## **ADDENDUM NO. 2**

## **NCSU** Renovations to the Don Ellis Building

SCO ID# 19-21547 NCSU ID# 201920037 SFK PROJECT NO. 1368-20

**December 13, 2023**

E-301

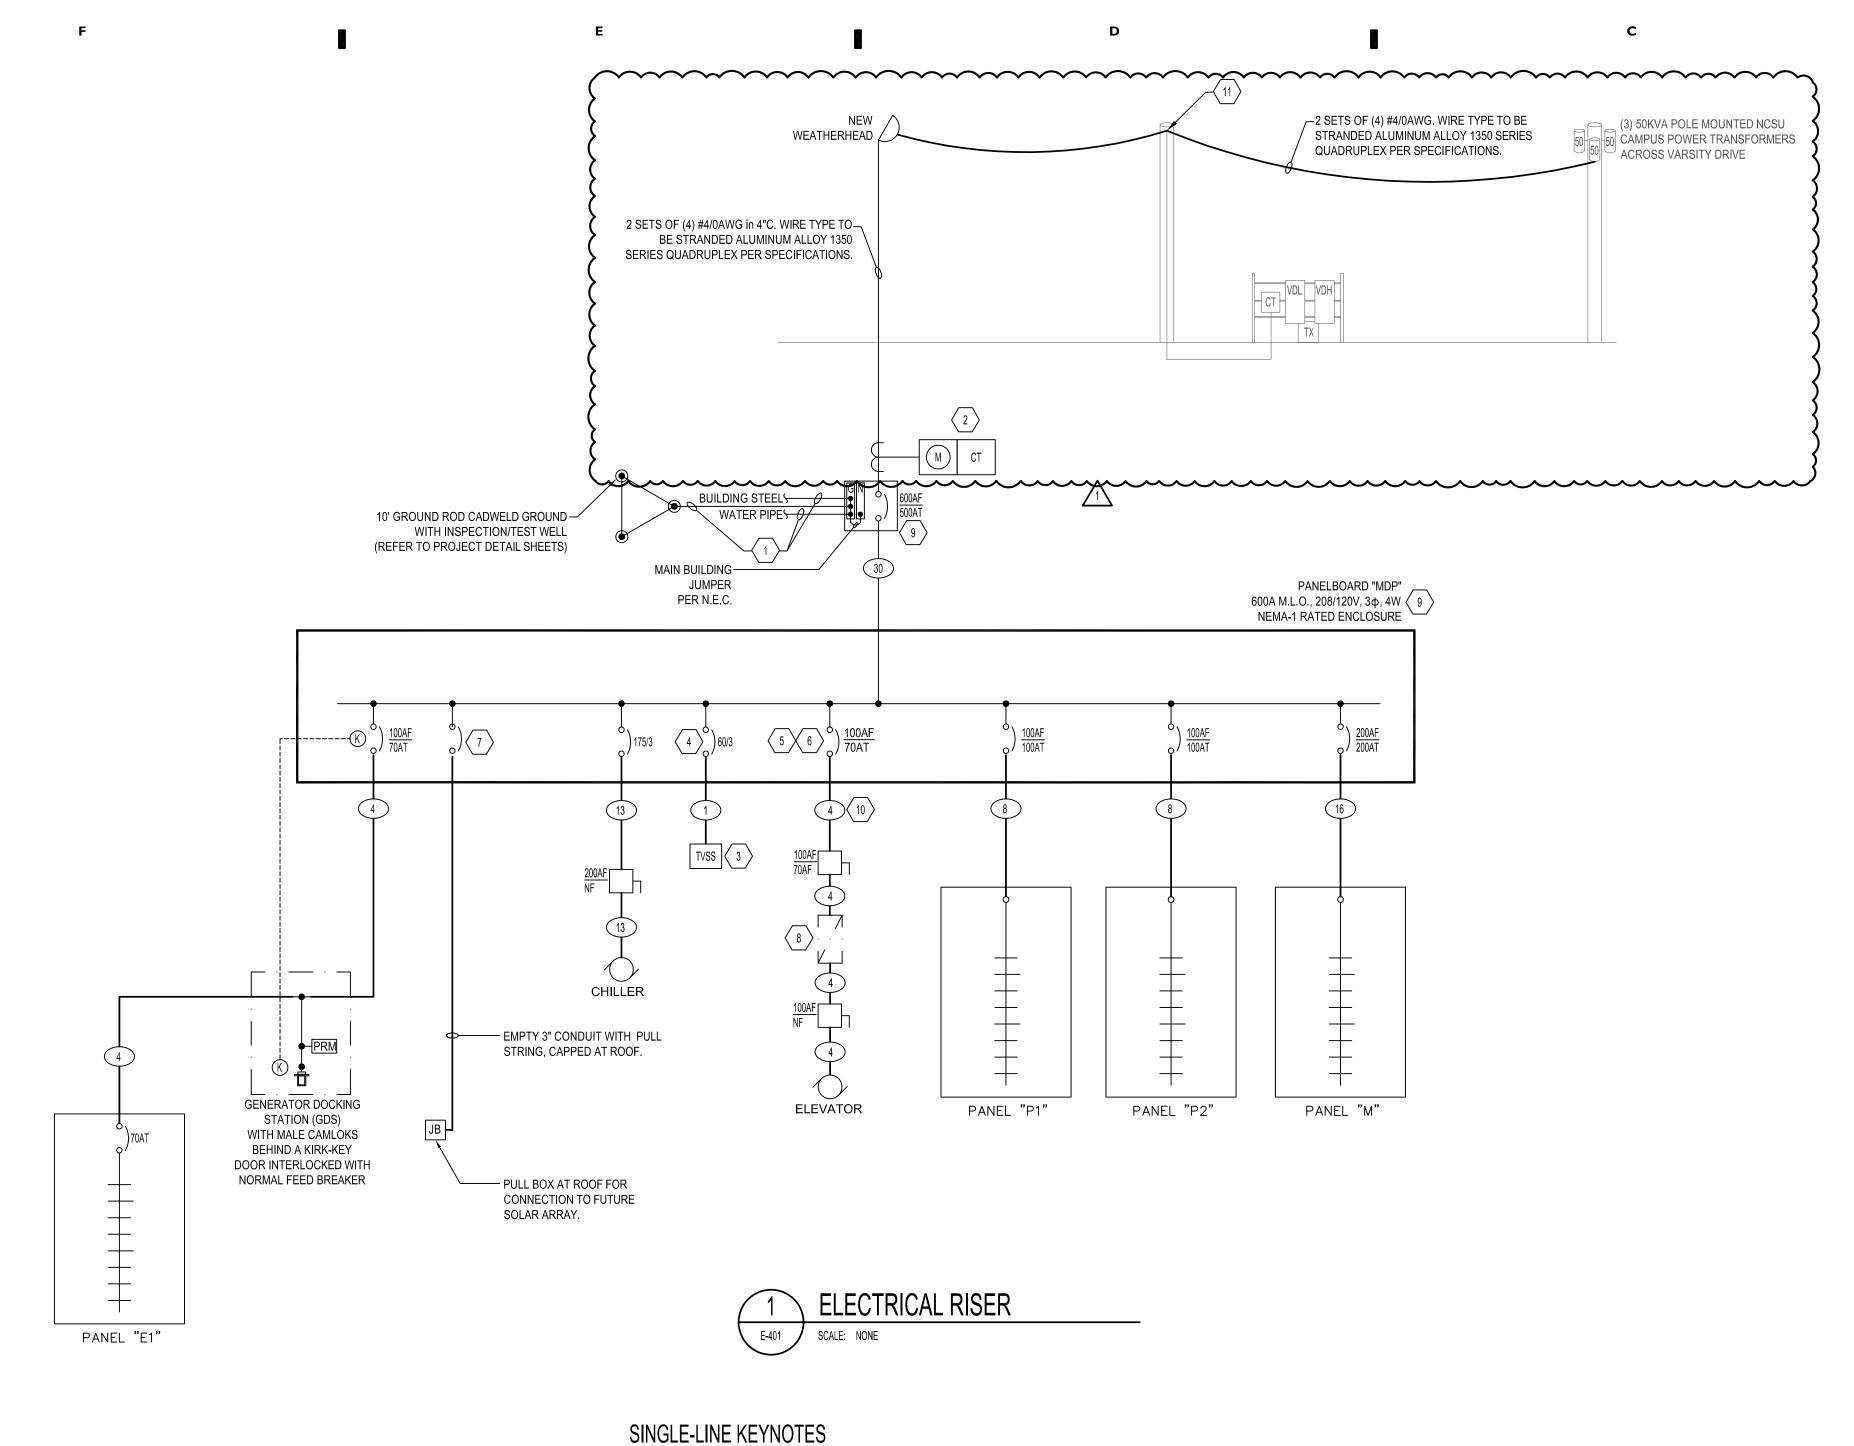
- 13. Sheet E-300: *Replace* with E-300 attached.
  - a. Revised to show double door to data room
- 14. Sheet E-301: *Replace* with E-301 attached.
  - a. Revised to show double door to data room
